UNITED STATES PATENT AND TRADEMARK OFFICE

10/720,752

Office Action Summary

DETAILED ACTION

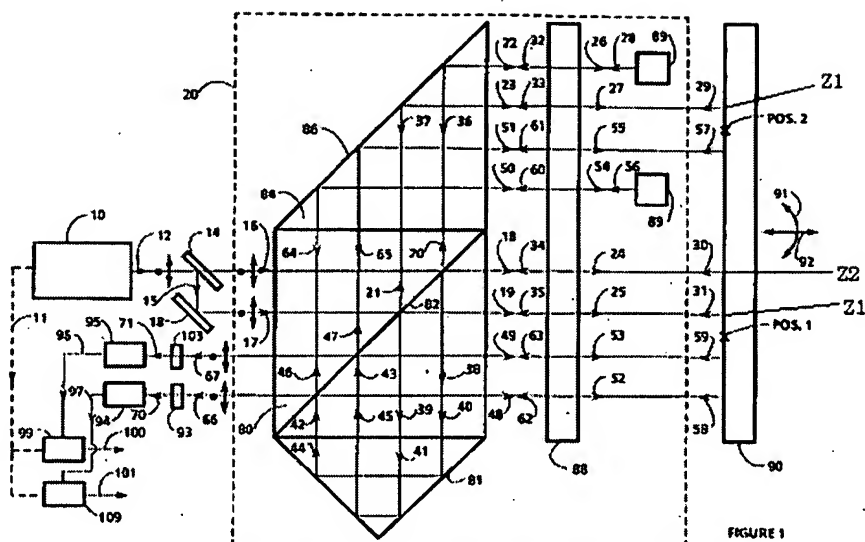
Claims 1-4, and 9 are rejected under 35 U.S.C. § 102(b) as being clearly anticipated by Sommargren(4,859,066).

Note that Z1 and Z2 were added by the Examiner to help explain the measurement mirror areas.

With regard to claim 1, Sommargren teaches an interferometer system for measuring displacement, along at least two directions within a three dimensional system of coordinates, of an object in a plane substantially parallel to a two dimensional plane(Fig. 1), said interferometer system comprising:

a single beam splitter configured to split a radiation beam associated with said plane mirror interferometer system and a radiation beam associated with said differential plane mirror interferometer system into respective measuring beams and respective reference beams(Fig. 1, 80);

a beam generator configured to generate a plurality of radiation beams(Fig. 1; 10,14,18), said beam generator comprising a single beam-splitter block(Fig. 1, 80) having a beam splitting surface(Fig. 1, 82);

said first measuring beam being reflected by a first measuring mirror area of said plurality of measuring mirror areas(Fig. 1; 90,POS.1+Z2), and wherein said beam splitting surface is configured to split at least one second beam of said plurality of radiation beams(Fig. 1, 17) into a second measuring beam(Fig. 1, 19) and a second reference beam(Fig. 1, 21),

said second reference beam being reflected by a first reflector that is fixedly positioned with respect to said beam-splitter block(Fig. 1, 89) and by at least one third mirror area, which is movable with respect to said beam-splitter block(Fig. 1; 90,POS.2+Z1).

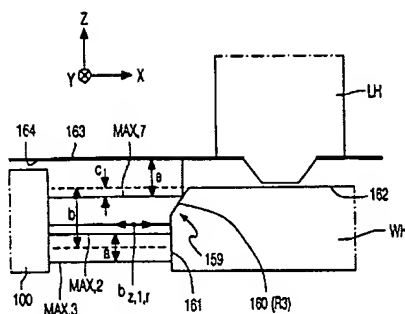
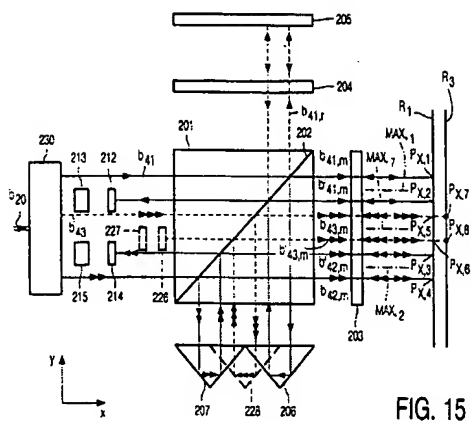
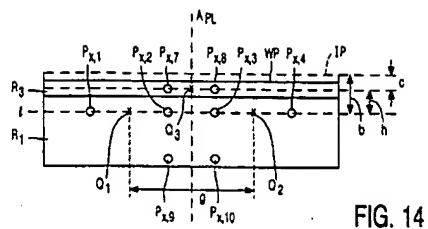
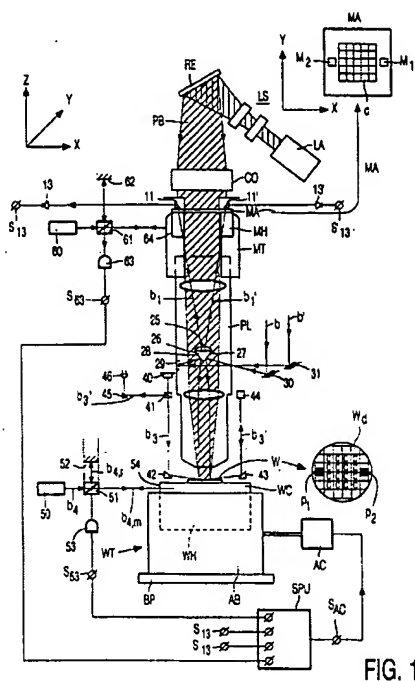
Loopstra et al teach a second reflector fixed to said object(Fig. 5, 160) and a second reference mirror(Fig. 5, 164) area located in a fixed position with respect to said beam-splitter block, wherein said second reflector is arranged to direct said second reference beam towards said second reference mirror area.

With regard to claims 5, 13, and 20; it would have been obvious to one of ordinary skill in the art at the time the invention was made to modify the interferometer of Sommargren by replacing the section of mirror from which beams 27 and 55 reflect(Fig. 1, POS.2±Z2) with an angled reflector and include a mirror on the projection lens in order to measure displacement of the XY-stage along a different angular axis.

Loopstra et al teach generating a plurality of beams(fig's 10,12; b₂₀) which occupy more than one plane(fig. 14; P_{x,1}-P_{x,10}) and a second radiation beam(fig. 15, b₄₃) in a position between two of said at least three first radiation beams(fig. 14; P_{x,7},P_{x,8}). Thus Loopstra et al can measure displacement along the X and Z axes

With regard to claims 7, 8, 15, 16, 22, and 23; it would have been obvious to one of ordinary skill in the art at the time the invention was made to modify Sommargren by generating a number of beams needed to measure displacement in four degrees of freedom, as suggested by Loopstra. One arrangement builds on the teaching of Sommargren which uses a single laser(Fig. 1, 10) a beam-splitter(Fig. 1, 10), and a reflector(Fig. 1, 10) to generated the first linear and differential interferometer beams.

By placing an additional beam-splitter/reflector in the path of the laser beam 12 oriented such that second linear interferometer beam 16' is generated and is reflected out of a plane formed by beams 16 and 17 into a second X-Y plane. Beam 16' would then follow the same beam paths as beam 16 except in a lower X-Y plane. The difference between the outputs of linear interferometer beams 16 and 16' is indicative of angular displacement about the Y-axis.

By replacing only the section of mirror from which beams 27 and 55 reflect(Fig. 1, POS.2±Z2) with an angled reflector and include a mirror on the projection lens a signal indicative of displacement along the Z-axis is generated. This would meet the limitations of claims 7, 15, and 22 of three first radiation beams occupying more than one plane(16,16',17) and a second radiation beam between two of the first radiation beams(16,17',17). This would also meet the limitations of claims 8, 16, and 23 of three first radiation beams arranged to occupy a polygon volume(16,16',17') and at least one second radiation beam in a position outside a polygon volume(17).
